**From:** Mohseni, Aby  
**Sent:** Tuesday, November 24, 2015 1:44 PM  
**To:** Mark Leyse  
**Cc:** Inverso, Tara; Kokajko, Lawrence; Burnell, Scott; Doyle, Daniel  
**Subject:** RE: Fwd: Status of PRM-50-93/95

**From:** Mark Leyse [<mailto:markleyse@gmail.com>]  
**Sent:** Sunday, November 22, 2015 8:10 AM  
**To:** Mohseni, Aby <[Aby.Mohseni@nrc.gov](mailto:Aby.Mohseni@nrc.gov)>  
**Subject:** [External\_Sender] Fwd: Status of PRM-50-93/95

Subject: Re: Status of PRM-50-93/95

**The severe-damage zone where thermal runaway occurred**--within approximately  $\pm 8$  inches at the 7 foot elevation.

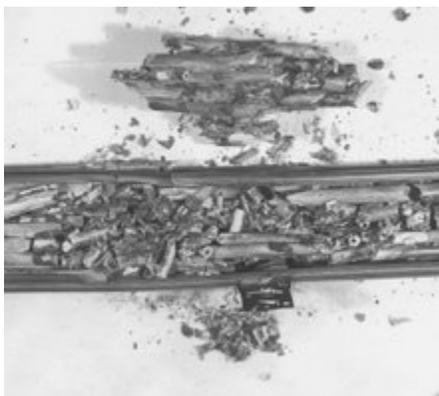
**Please answer the following two related questions:**

**First)** Would you please acknowledge that the NRC's TRACE simulation of FLECHT Run 9573 did **not** predict what cladding temperatures would be at the test bundle's **7 foot elevation** at either 18 seconds or 18.2 seconds?

**Second)** Would you please acknowledge that the NRC's TRACE simulation of FLECHT Run 9573 did **not** predict what steam temperatures would be around the test bundle's **7 foot elevation** at either at 16 seconds, 18 seconds, or 18.2 seconds?

An adequate TRACE simulation of Run 9573 would have predicted cladding temperatures for the test bundle's 7 foot elevation at either 18 seconds or 18.2 seconds. Or an adequate TRACE (or another code or a modified version of TRACE) simulation of Run 9573 would have predicted steam temperatures around the test bundle's 7 foot elevation at either 16 seconds, 18 seconds, or 18.2 seconds.

Such a TRACE simulation of Run 9573 could have been compared to the Westinghouse data indicating that thermal runaway occurred around the test bundle's 7 foot elevation.
